Technical analysis of the 6-MTPA project

Figure 1: Geomorphology of the study area

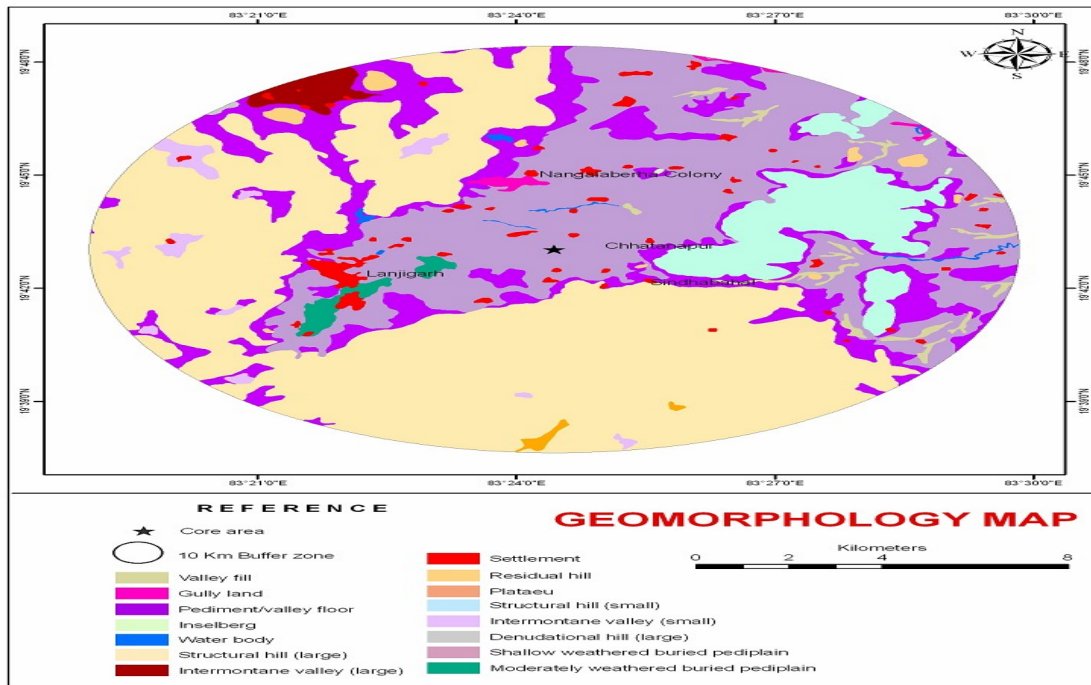
- **Location and its impact on air:** The inherent location of the project makes it very sensitive not only from the biodiversity point of view but also from the air pollution perspective. The existing plant is located in a valley, which is surrounded by mountains from three sides (see Figure 1). This makes the impact of the air pollution much more severe during the night. The cold air flows into valley in the night as a result it brings the pollutant plume back into the valley instead of dispersing it (see figure 2). Problem is acute particularly during the winter, when the air becomes stagnant due to the inversion condition.

Note: According to above figure, large hills are present in S, SW and NW from the plant. In the eastern part of the plant small hills range are present.

Figure 2: Effect of valleys on dispersion

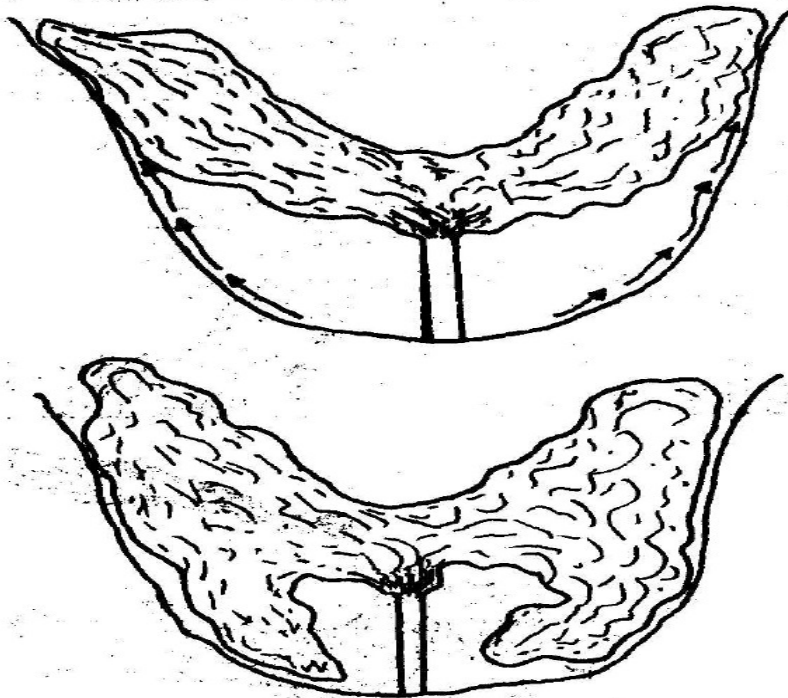
Clearly, the ambient air in the area has deteriorated over a period of time on virtue of its location. According to the previous EIA report, prior to the commissioning of the refinery (1 MT), the ambient air quality met the standards prescribed for sensitive area (annual average 70 microgram/Nm³). However, the change in air quality is visible as is evident from the ambient air quality report as provided in the EIA report for expansion (see table 1).
